**Transmittal  
Report of Results  
Basis for Site Remedy Revised Addendum  
39155 and 39183 State Street  
Fremont, California**

**Subject:** Basis for Site Remedy Revised Addendum  
39155 and 39183 State Street  
Fremont, California

**Project No.: 220.003.03.003**

**Proposed Trench Dam and Trench Plug Locations**  
State Street Center  
Fremont, California

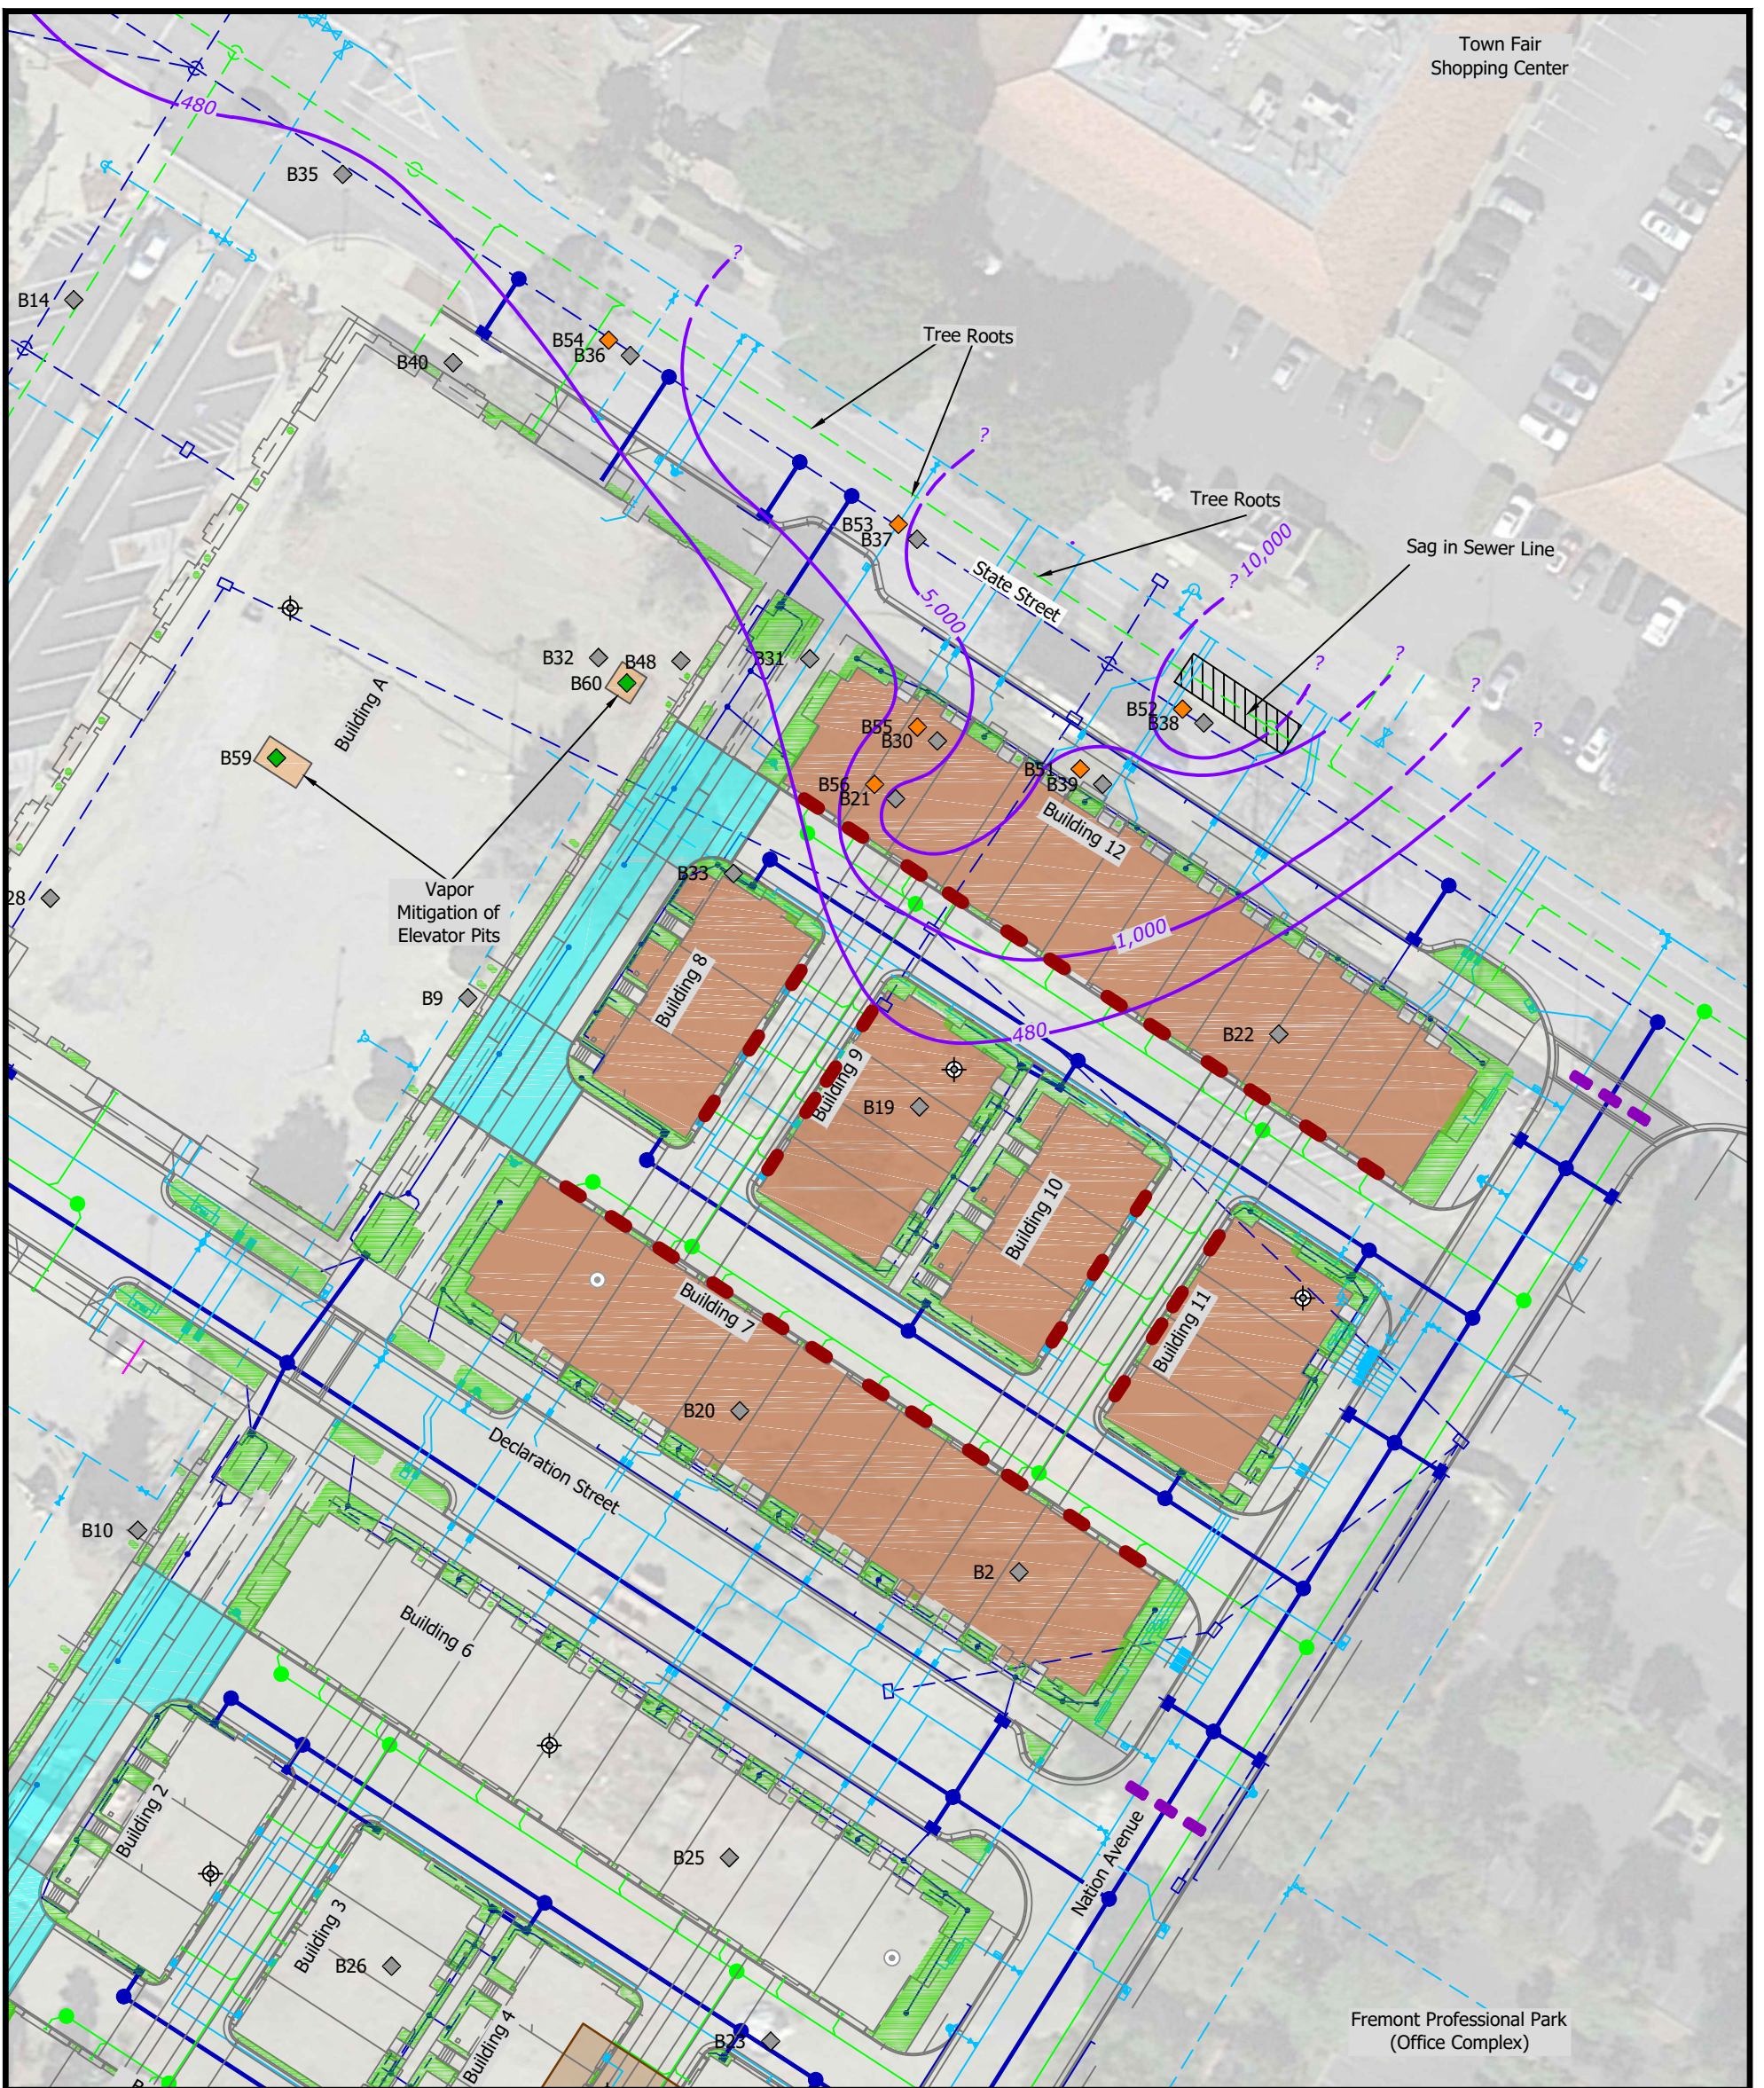
In order to prevent the potential migration of soil vapors along main utility line corridors that run from the State Street area to other areas of the site located south of Declaration Street, trench plugs are now proposed to be included along Nation Avenue. The attached Plate 1 provides the proposed locations where utility lines will require trench plugs. The trench plugs are proposed to be installed along the water, storm and sanitary sewer main lines near the intersection of Nation Avenue and State Street and near the intersection of Nation Avenue and Declaration Street. Appendix B includes the Trench Dam & Trench Plug Plan construction drawing that shows the proposed trench plug locations and a trench plug detail.
